ERRATA SHEET

Report Number: NUREG/CR-6227
PNNL-9433

Report Title: Performance Demonstration Tests for Eddy
Current Inspection of Steam Generator Tubing

Figure 5. Plots of Equations 4, 5, and 6, for 0.875 in. OD x 0.050 in. Wall Thickness Tube. Flaw Length \geq 0.875 in.

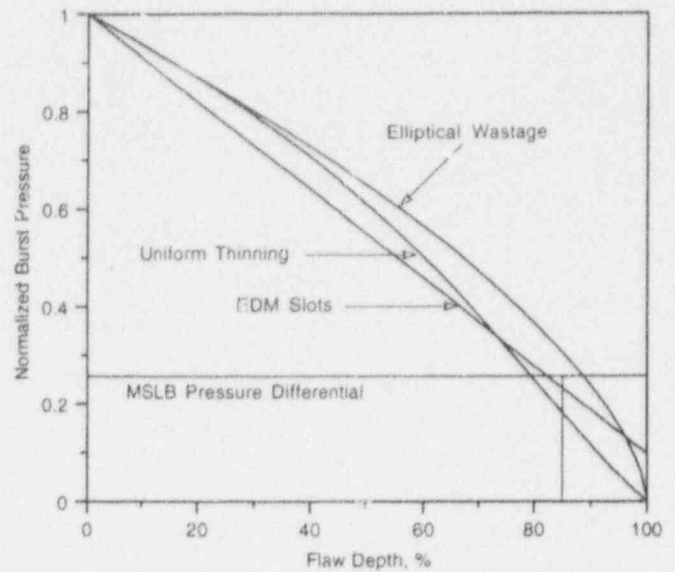
Instructions: Please replace page 8 of the above NUREG with the
attached revised page 8. Figure 5 on this page has been
replotted to correct an error in the curve denoted
"EDM Slots." The wrong value for the inner radius
was used in Equation 4 on page 7 when generating the
data for this particular curve.
